ECE/TRANS/WP.29/2009/79
9 April 2009

Proposal for Corrigendum 1 to Supplement 33 to the 03 series of amendments to
Regulation No. 37
(Filament lamps of power-driven vehicles and their trailers)

Submitted by the Working Party on Lighting and Light-Signalling */

Sheet H10W/1

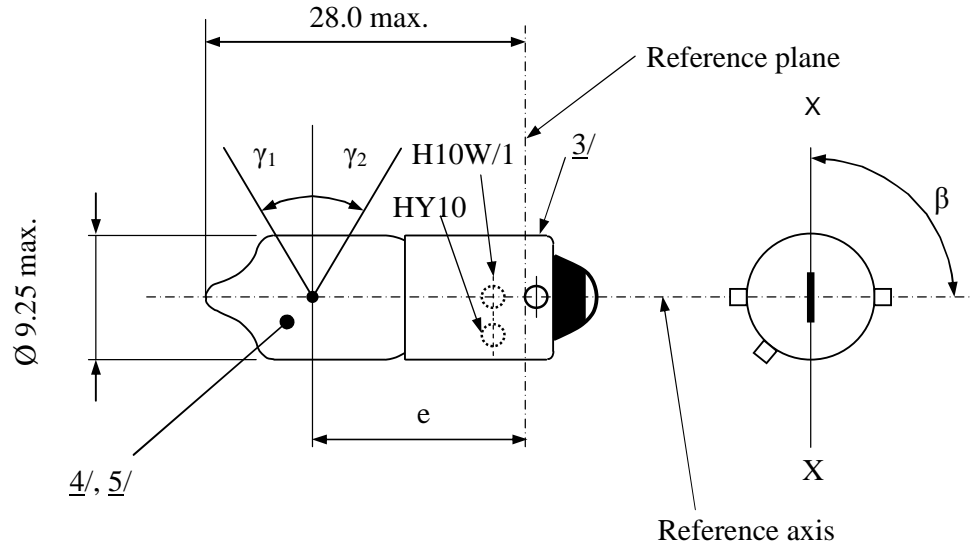
Sheet H10W/1, the table, amend to read:

Cap:	H10W/1	BAU9s	in accordance with IEC Publication 60061 (sheet 7004-150A-1)
	HY10W	BAUZ9s	in accordance with IEC Publication 60061 (sheet 7004-150B-1)

The new sheets H10W/1 to 2, between sheet H6W/1 and sheet H21W/1, amend to read (see next pages):

Dimensions in mm		Filament lamps of normal production			Standard filament lamp
		min.	nom.	max.	
e		14.25	15.0	15.75	15.0 ± 0.25
Lateral deviation	<u>1/</u>			0.75	0.4 max
β		82.5°	90°	97.5°	90° ± 5°
γ_1, γ_2	<u>2/</u>	30°			30° min.
Cap:	H10W/1: BAU9s HY10W: BAUZ9s	in accordance with IEC Publication 60061 (sheet 7004-[...]) in accordance with IEC Publication 60061 (sheet 7004-[...])			
ELECTRICAL AND PHOTOMETRIC CHARACTERISTICS					
Rated values	Volts	12			12
	Watts	10			10
Test voltage	Volts	13.5			13.5
Objective values	Watts	12 max.			12 max.
	Luminous flux	H10W/1	200 ± 12 %		
		HY10W	120 ± 17 %		
Reference luminous flux at approximately 13.5 V					White: 200 lm Amber: 120 lm

- 1/ Maximum lateral deviation of filament centre from two mutually perpendicular planes both containing the reference axis and one containing axis X-X.
- 2/ In the area between the outer legs of the angles γ_1 and γ_2 , the bulb shall have no optically distorting areas and the curvature of the bulb shall have a radius not less than 50 per cent of the actual bulb diameter.
- 3/ Over the entire length of the cap there shall be no projections or soldering exceeding the permissible maximum diameter of the cap.
- 4/ The light emitted from filament lamps of normal production shall be white for category H10W/1 and amber for category HY10W.
- 5/ The light emitted from standard filament lamps shall be white for category H10W/1 and amber or white for category HY10W. "
